**Comments of the National Coalition for Advanced Transportation**

**Docket Nos. NHTSA-2018-0067, EPA-HQ-OAR-2018-0283, NHTSA-2017-0069**

**Subject:** Material for today's Light-duty GHG NPRM discussion.

# Summary points from EPA review of CAFE model (NPRM version) – Effect of EPA code revisions

**Figure 7 Effect of CPMref assumptions on CPMrate with 20 percent rebound (hypothetical example shown for MY2025 vehicle with 10 percent fuel economy improvement from MY2016 vehicle)**

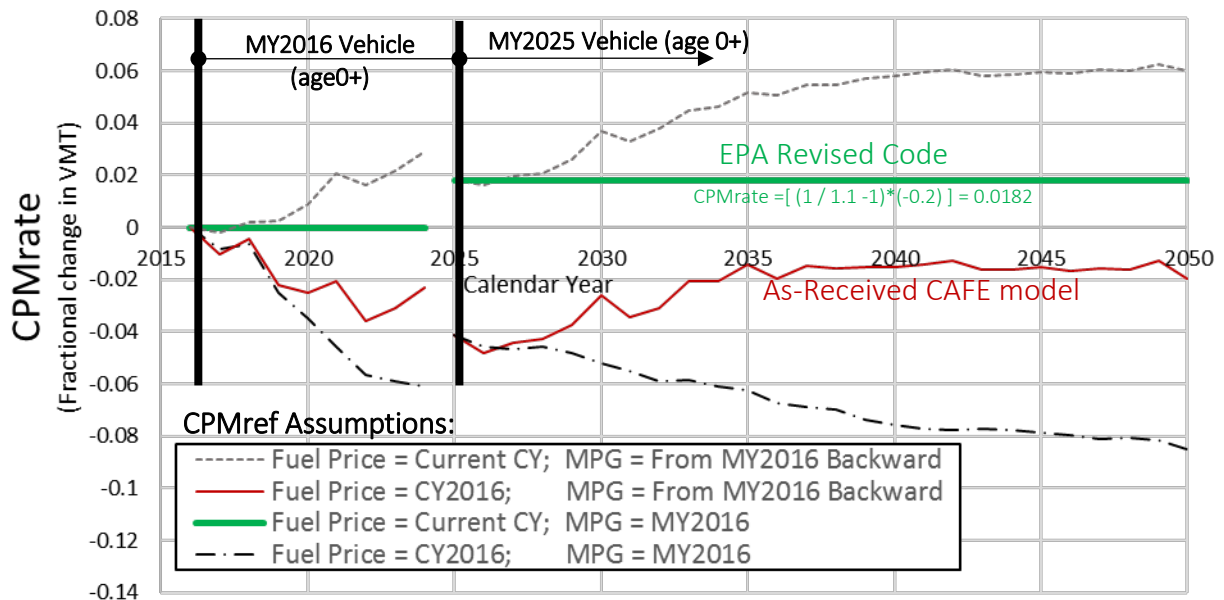
A hypothetical example will help to illustrate the importance of making appropriate assumptions when selecting CPMref. Building off the example in Figure 5 with MY2025 improvements to an average MY2016 car with fuel economy of 36.9mpg, Figure 7 shows how the CPMrate (and therefore the VMT) can change dramatically based on assumptions for CPMref. The inappropriate referencing of progressively older fleet average fuel economy values (red and gray curves), causes the CPMrate to be higher than when constant MY2016 reference fuel economy values are used (black and green curves.) The inappropriate referencing of CY2016 fuel prices (red and black curves) causes the CPMrate to be lower than when the current CY fuel prices are used (gray and green curves.) While these two problematic assumptions for CPMref tend to work in opposite directions, the general tendency of the As-Received model to produce a negative CPMrate in the example in Figure 7, despite the improvement in fuel economy, seems to indicate the assumption of maintaining CY2016 fuel prices is dominant.

We believe that the most defensible implementation of the rebound effect is one that maintains the same CPMrate over every calendar year in the course of a vehicle lifespan. In the example shown by the green line in Figure 7, the CPMrate for the MY2025 vehicle then becomes simply a function of the ratio of the reference fuel economy to the new fuel economy and the 20 percent rebound effect value, or  $[(1 / 1.1) - 1] * (-0.2) = 0.0182$ . To achieve this, we revised the CAFE model code so that:

**Figure 8 Cost and Effectiveness of MY2030 vehicles relative to a ‘null’ tech package (PEV’s are off chart area, but included in fleet average)**

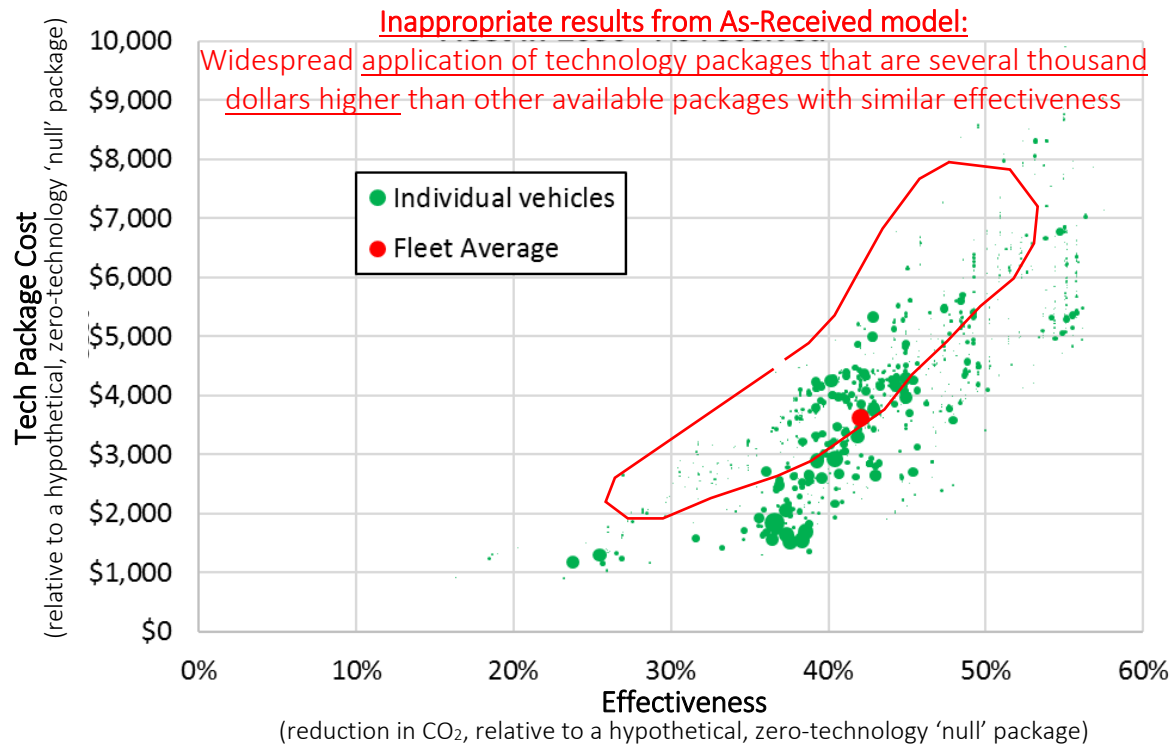
Figure 8 shows the total technology cost and effectiveness for all technology packages applied by the As-Received CAFE model to the MY2030 fleet, relative to a ‘null’ package with only basic technologies.<sup>12</sup> While we would not expect manufacturers to consistently apply technology packages that lie exactly on the cost-efficient ‘frontier’, the frequency with which the As-Received CAFE model applies packages that are several thousand dollars more expensive than other available packages is striking.

To resolve the issue of the cost-ineffective technology application decisions, EPA revised two elements of the CAFE model code. First, we revised “efficiency” calculation used for package ranking. Because we don’t believe that the value of a CO<sub>2</sub> credit to any manufacturer can be reasonably determined in advance<sup>14</sup>, we have removed the monetary valuation of CO<sub>2</sub> credits from the numerator of Equation 3, and instead include the change in quantity of compliance credits (in grams CO<sub>2</sub>) as a normalizing factor in the denominator of the efficiency calculation. The modified calculation, shown as Equation 6, can be interpreted as the cost-efficiency of a technology application in terms of the net cost per gram CO<sub>2</sub> credits earned. We think that this decision rule would reasonably represent a manufacturer that is applying technologies in a cost-minimizing manner, subject to all the original constraints on technology availability and redesign cycles specified in the As-Received CAFE model input files. As with the As-Received CAFE model logic, our revised code prioritizes technology packages with more negative efficiency values.

**Figure 9 CO<sub>2</sub> Credit Value, by Model Year, as defined in As-Received CAFE model inputs**

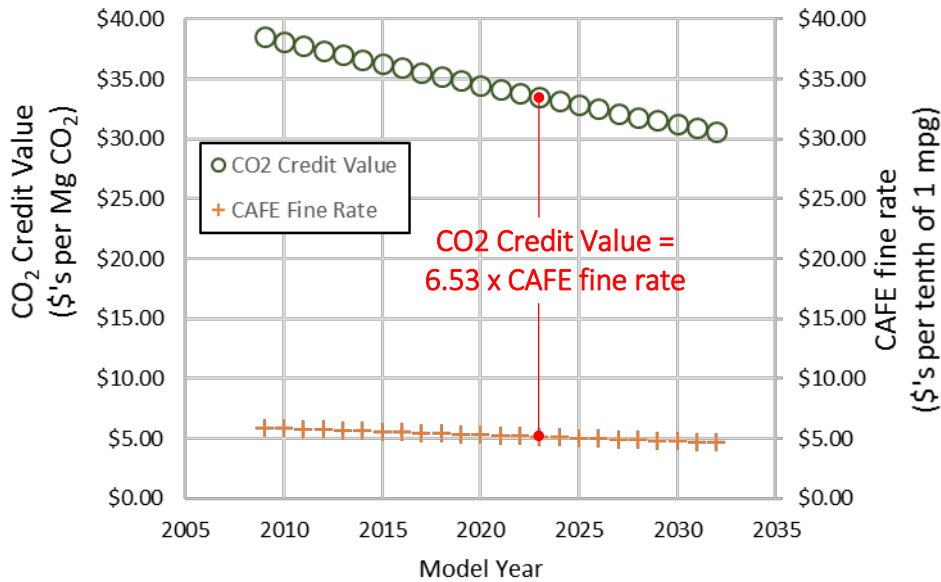
Figure 9 shows the CO<sub>2</sub> Credit Values by Model Year, which are defined in CAFE model input files using a simple scaling of the CAFE fine rates by a constant factor of 6.53. While the application of a uniform credit value is problematic given all the potential variations among manufacturers, it is probably even more problematic that the CO<sub>2</sub> value is assumed to be decreasing over time. Given that the GHG program does not allow manufacturers to pay fines as a compliance strategy, we assume that NHTSA’s intent was for the CO<sub>2</sub> credit value to represent a market value for trading credits between manufacturers. Regardless of the intent, as the adoption of the lower-cost technologies leaves only the more expensive alternatives available to meet future year stringency increases, it is implausible that the value of CO<sub>2</sub> credits to a manufacturer will decrease in this way over time.

**Figure 10 Effect of truncating CO<sub>2</sub> credit value in CAFE model's 'efficiency' calculation for tech package selection**  
 Assuming \$3/gal fuel price, \$35/MgCO<sub>2</sub> credit value, and 30k miles driving in first 2.5 years (for consumer payback)

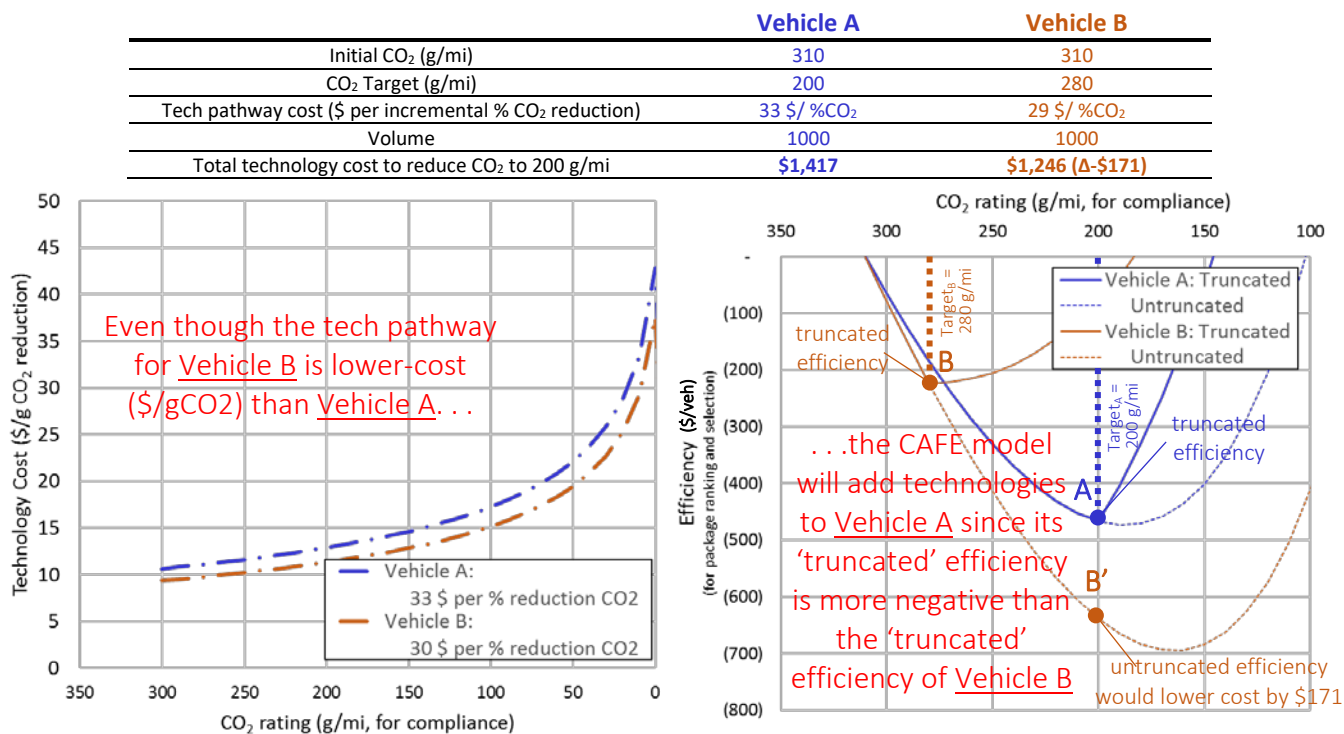
as shown in Figure 10, since the credit value for reducing Vehicle B below its 280 g/mi target is truncated and not included in the efficiency calculation. The CAFE model will choose to apply technology to Vehicle A to reduce CO<sub>2</sub> to 200 g/mi, even though that technology pathway is less cost effective than one where technology is applied to Vehicle B (point B' in Figure 10) – with a technology cost of \$1,417 for Vehicle A compared to \$1,246 for Vehicle B for the same CO<sub>2</sub> reduction.

**Figure 2 Incremental Effectiveness of TURBO2 to CEGR1 (MedCarPerf class)**

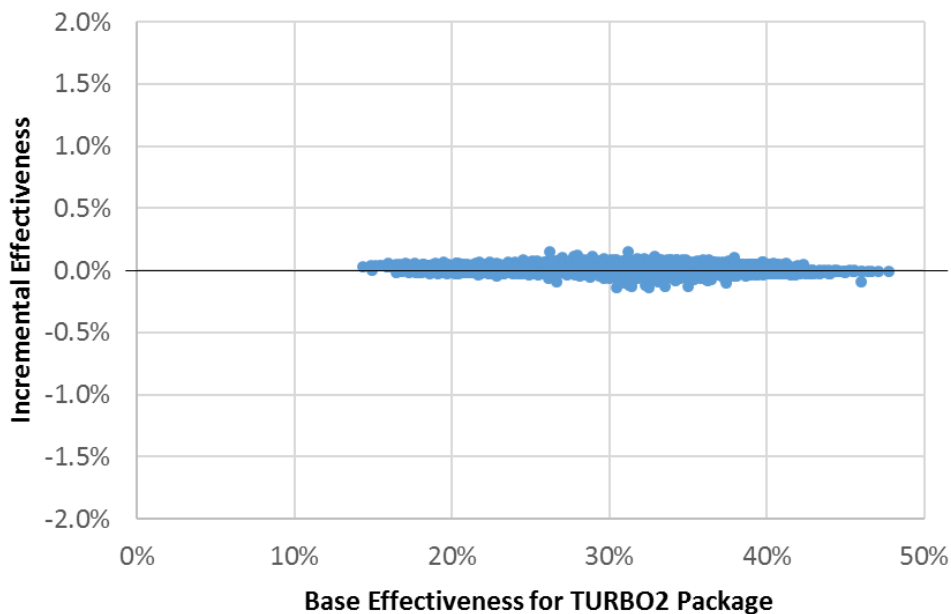
**Observation 3:** *The addition of cooled exhaust gas recirculation (CEGRI) onto turbocharged engines (TURBO2) provides no relative benefit, despite the additional cost of the technology. Given this input assumption, the CAFE model outputs, as expected, do not show application of CEGRI.*

A cooled EGR package when added to the advanced turbocharged engine (TURBO2) has a cost of \$334 in 2030. Cooled EGR is a technology that has been used in the market, and has a significant effect on CO<sub>2</sub> reduction. However, as illustrated in Figure 2, the incremental effectiveness is at or near zero for EPA findings on initial review of NHTSA Jan-22, 2018 CAFE model runs (final version for 2/12/2018 NHTSA briefing)

nearly all packages (and averaging zero for all packages). The “Medium Car Performance” class shown in the figure is representative of the near-zero effect of the technology for all classes.

**Figure 3 Incremental Effectiveness of the best six-speed (AT6L2) v. the best eight-speed (AT8L3) (Small SUV)**

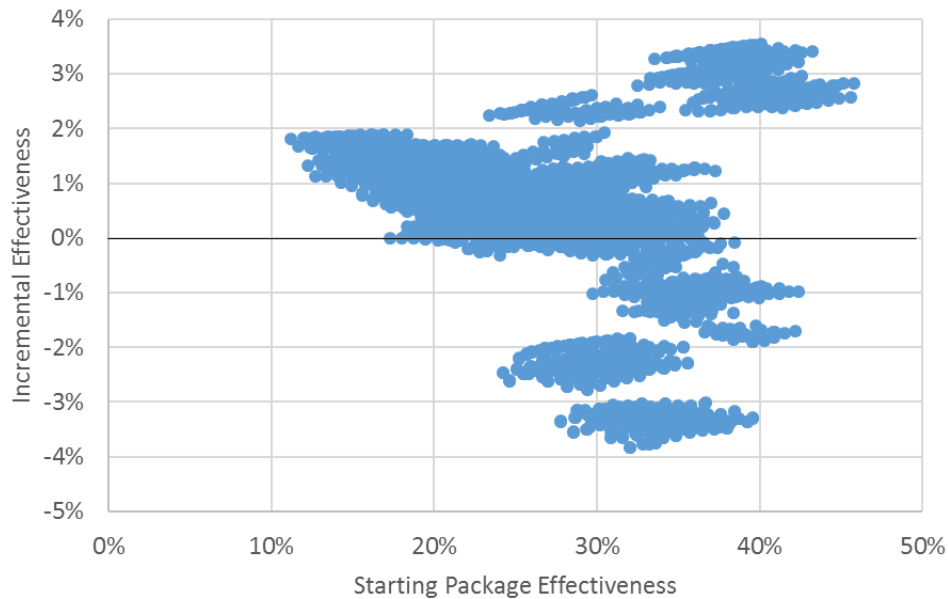
The modeled automatic transmissions include one “improved” level of a six-speed automatic (AT6L2) and two improved levels of eight-speed automatics (AT8L2 and AT8L3). The cost of the AT6L2 package (additional to an AT6) is \$362 in 2030. The cost of the AT8L3 package (additional to an AT8) in 2030 is nearly the same (\$358). Incremental to the AT6, the best eight-speed package is \$485 (i.e., \$123 more than the AT6L2). However, on average, the technology inputs provided show that the AT8L3 is only 1% more effective than the AT6L2, and in some cases is worse (as shown by the Small SUV plot).

**Figure 5 Incremental Effectiveness of 48V Mild Hybrid with belt-integrated starter-generator (BISG) to crank-integrated starter-generator (CISG) (Small Car class)**

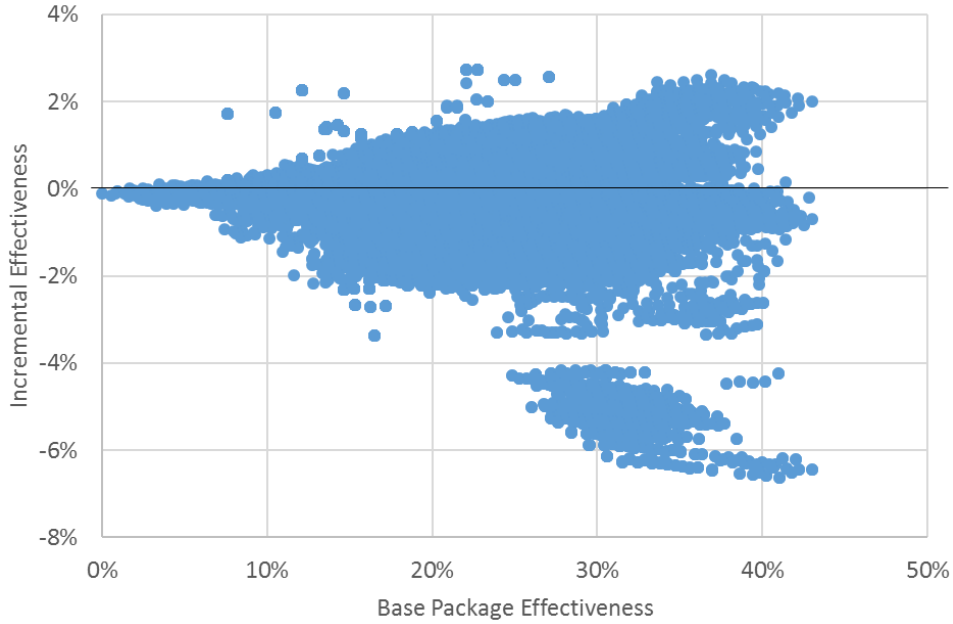
However, on average, the CISG is slightly less effective than the BISG, although with a wide spread of effectiveness. The small car example shown in Figure 5 is typical, with the incremental effectiveness of most packages between about +1% and -1%.

**Figure 9 Fixed Effect Values used in the Safety Analysis**

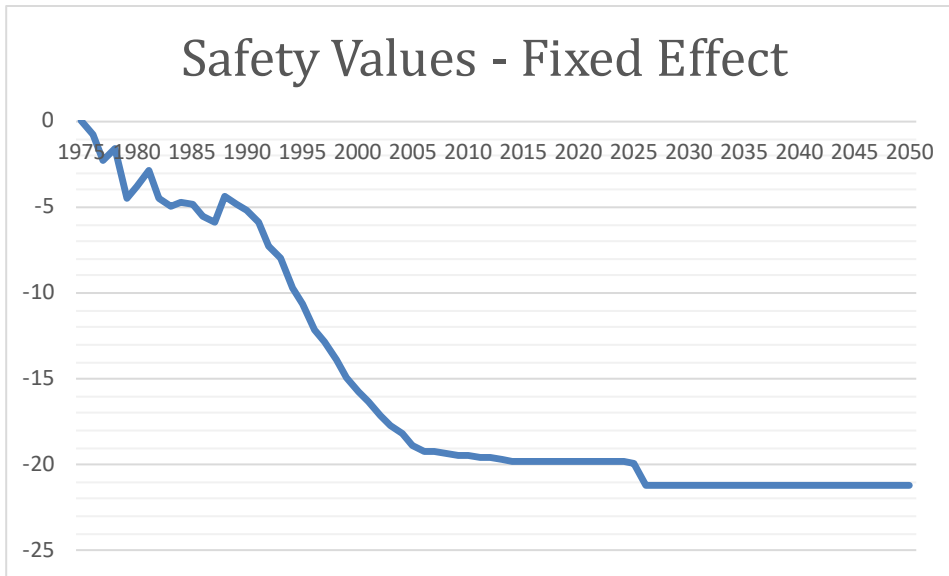
Question/Information Request 17. How are the “fixed effects”, as presented in the safety values sheet of the parameters input file estimated? Why are values flat from 2014 through 2021? Why do they decrease beyond 2021? Why the large step change reduction in 2026 with a flattening beyond 2026?

**Figure 9: EPA Observations of Transmission Effectiveness**

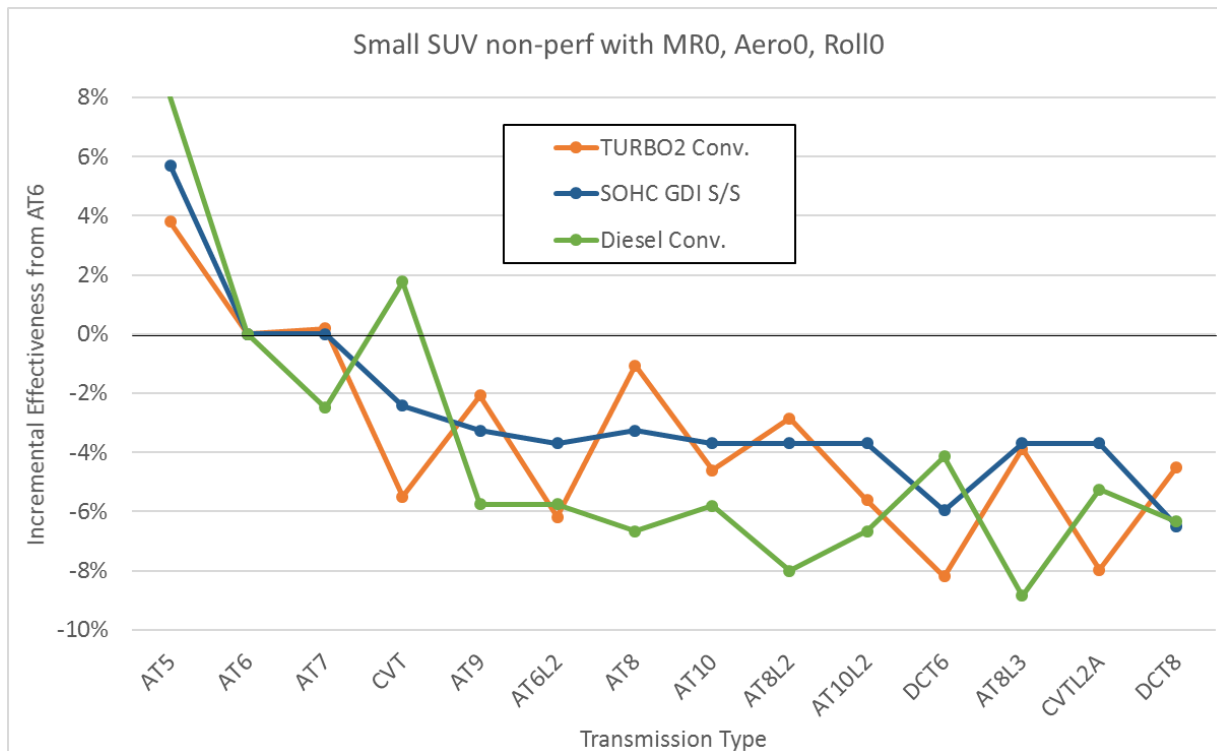
As part of the review process with NHTSA, NHTSA requested additional information and specific examples of vehicle technologies that did not follow the logical progression of transmission technology and commensurate effectiveness. In response EPA provided Figure 9: EPA observations of transmission effectiveness below. This figure shows that as advanced transmission technologies are applied to several powertrain types, there are instances where the more advanced transmission demonstrates lower effectiveness than the less advanced transmission. In addition, to this chart EPA also provided the exact technology package references from the CAFE model inputs. As of this summary, NHTSA has not yet responded to this observation.

**Figure 12: EPA’s Observations of Negative Effectiveness for Start/Stop Packages**

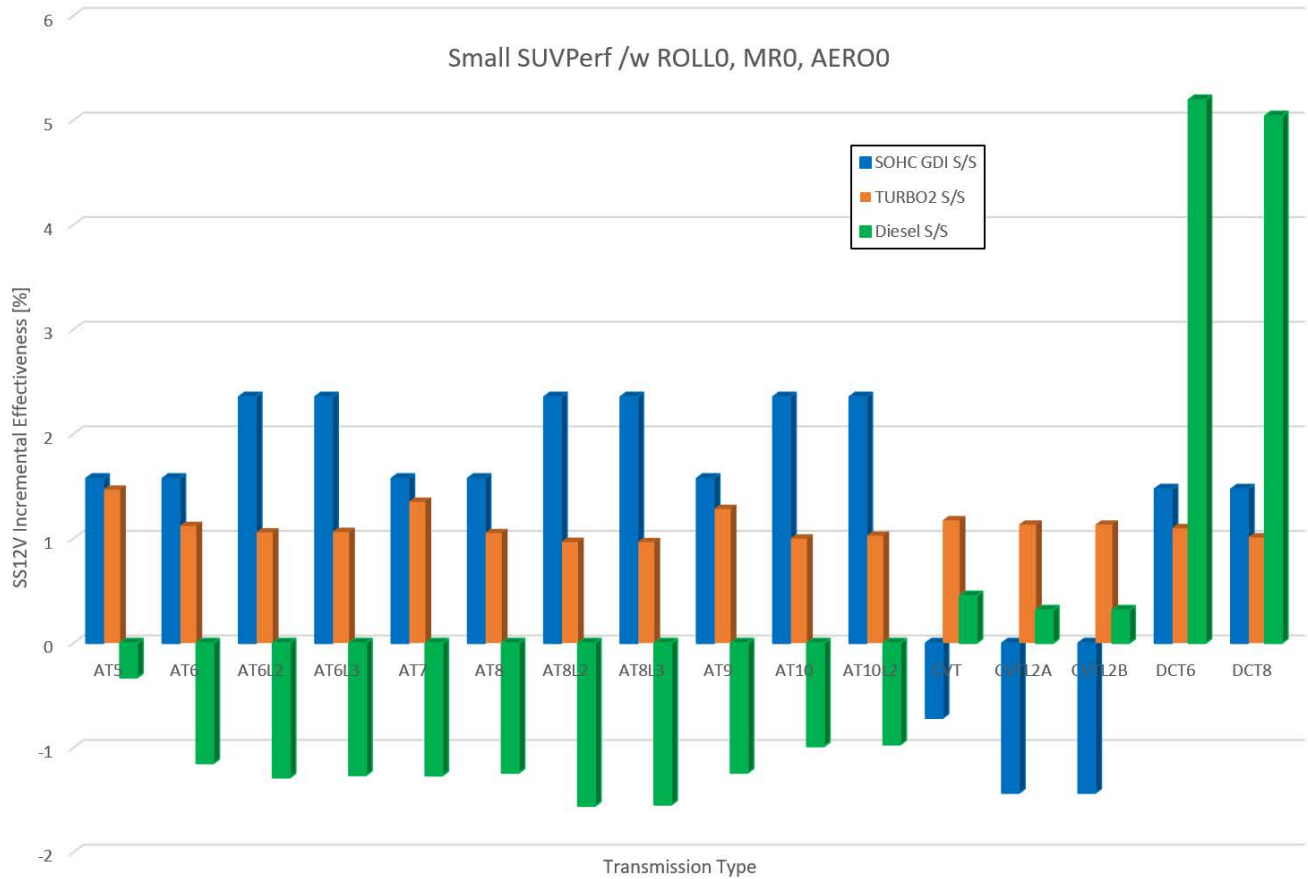
In addition to examples of unexpected transmission effectiveness estimates, NHTSA also requested examples of observed negative 12V start-stop effectiveness. In Figure 12: EPA’s Observations of Negative Effectiveness for Start/Stop Packages, below, EPA has identified 12V start/stop packages that demonstrate negative effectiveness. These results are not rational. There are not situations under which turning off the engine instead of allowing the engine to idle would result in increased fuel consumption. In addition, for those packages with the same engine and positive effectiveness, it is also unexpected to observe such large variation in start/stop effectiveness. A SOHC GDI S/S should consume the same amount of fuel at idle independent of being mated to an AT8 transmission or an AT8L2 transmission.
